# Oil Sands Environmental Coalition

**Re: The Canadian Natural Resources Limited Tailings Management Plan for the Horizon Mine OSCA Application No. 1869003**

**Figure 1:** Expected Cumulative Tailings Under the TMF<sup>5</sup>

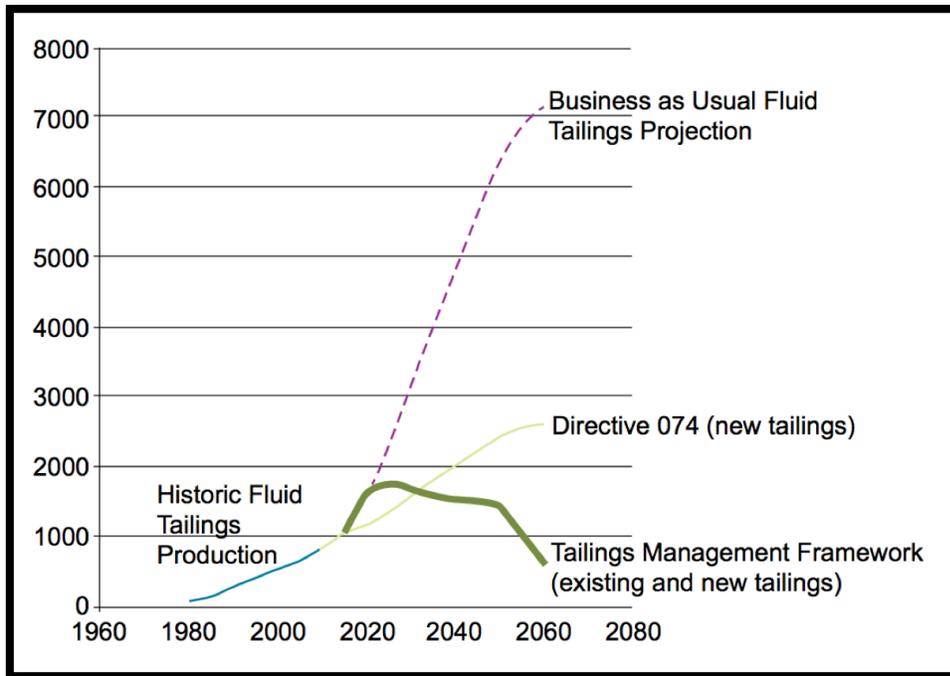
The TMF graphically outlines the expected cumulative trajectory of all fluid tailings on the landscape including a peak date for tailings accumulation, a rate of decline, and the point at which tailings cumulative tailings volumes will actually decline (**Figure 1**). OSEC has amalgamated the projected tailings volumes from all Directive 085 applications submitted to date, and compared it with the aforementioned TMF trajectory (**Figure 2**). This analysis has demonstrated a general trend wherein cumulative tailings volumes are peaking roughly ten years later than the TMF anticipated. This analysis will be expanded to include the projected fluid tailings volumes of all Alberta oilsands mines once the remaining tailings management plans have been submitted for the November 2016 deadline.

**Figure 2:** Cumulative Tailings Volumes of All Directive 085 Applications Submitted to Date

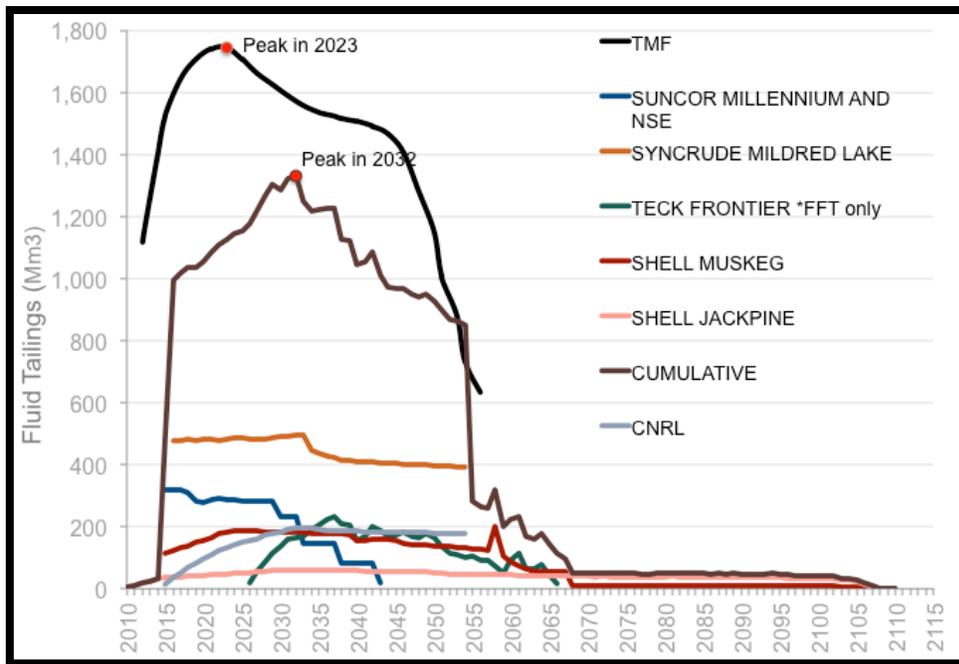
OSEC and the AER's ability to determine the adequacy of CNRL's plans are correspondingly dependent on an assessment that the sum of the approved tailings plans are consistent with the TMF's objectives. As such, it is essential for regulators and stakeholders to be able to compare all tailings plans in conjunction to ensure responsible regulatory decisions are made. We thereby strongly recommend that no applications be approved until all proponent plans have been submitted and reviewed.
